**WASTEWATER STUDY
TIMBERS AT BLACK FOREST SUBDIVISION
9220 ARROYA LANE
PARCEL NO. 52054-00-041
EL PASO COUNTY, COLORADO**

Prepared for:
Timbers at Black Forest Subdivision 2025, LLC
3880 Inspiration Drive
Colorado Springs, Colorado 80917
Attn: Michael Turner

March 5, 2026

OWTS SUITABILITY MAP

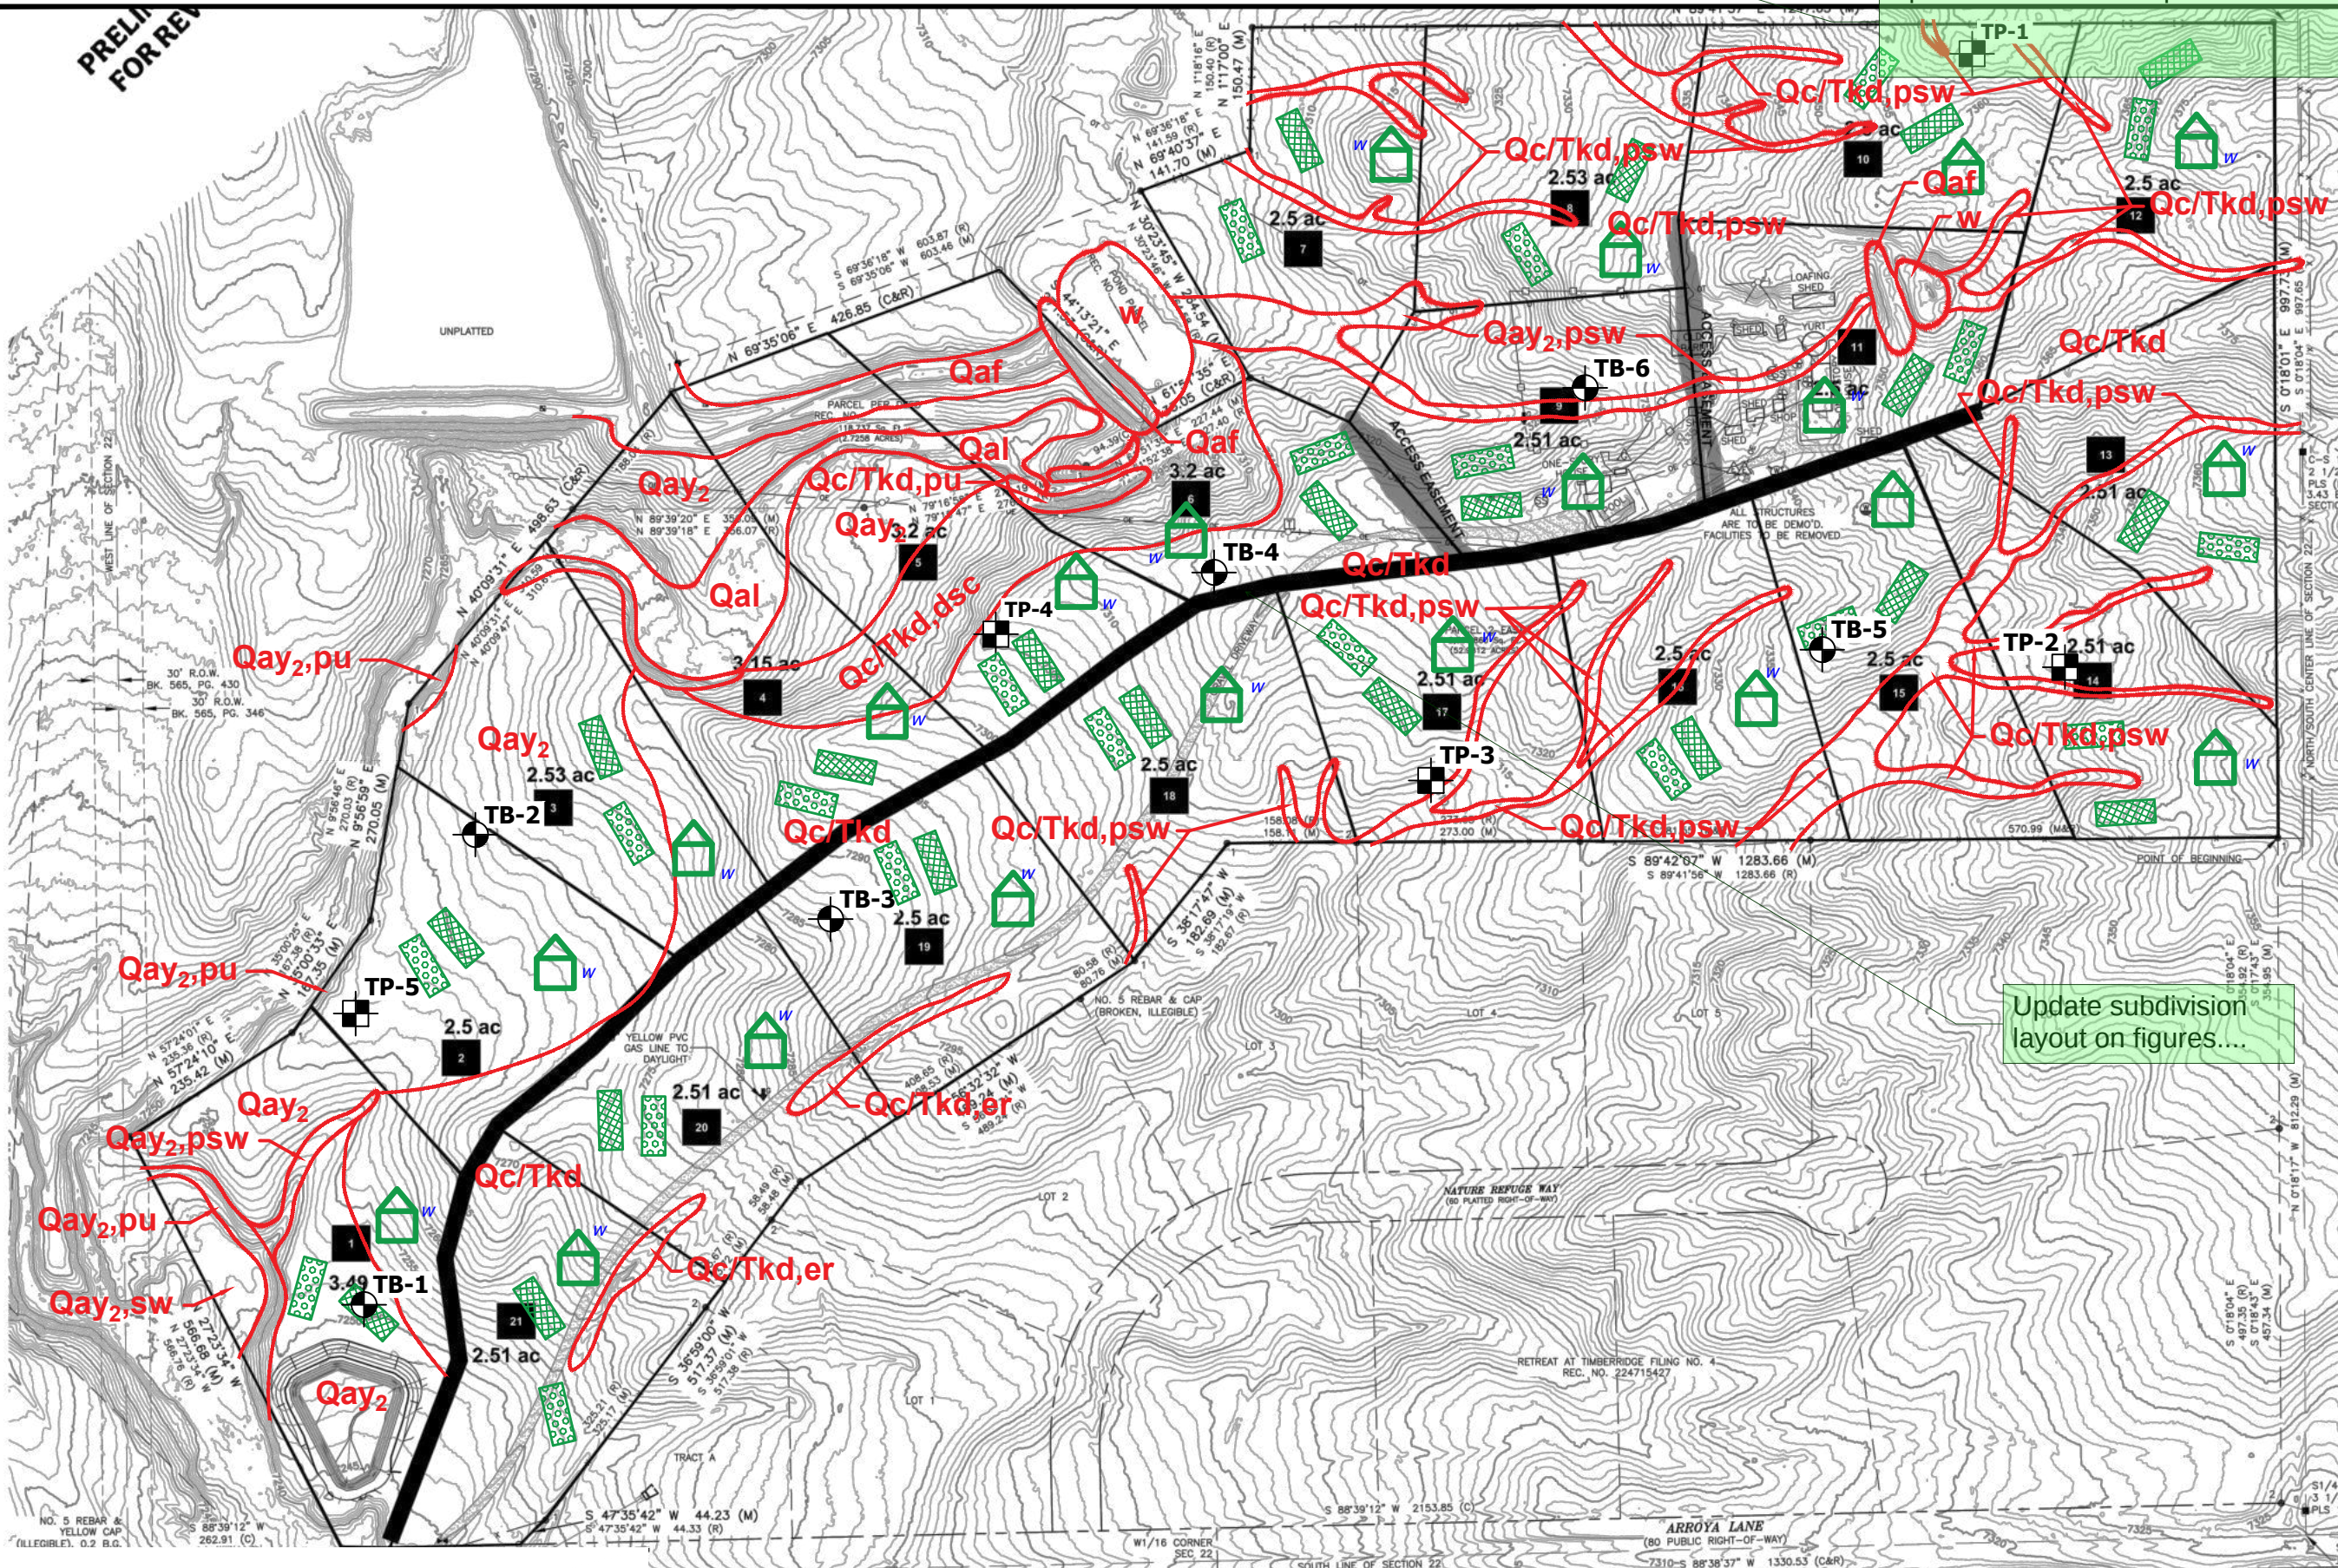
Update subdivision map with information laid over
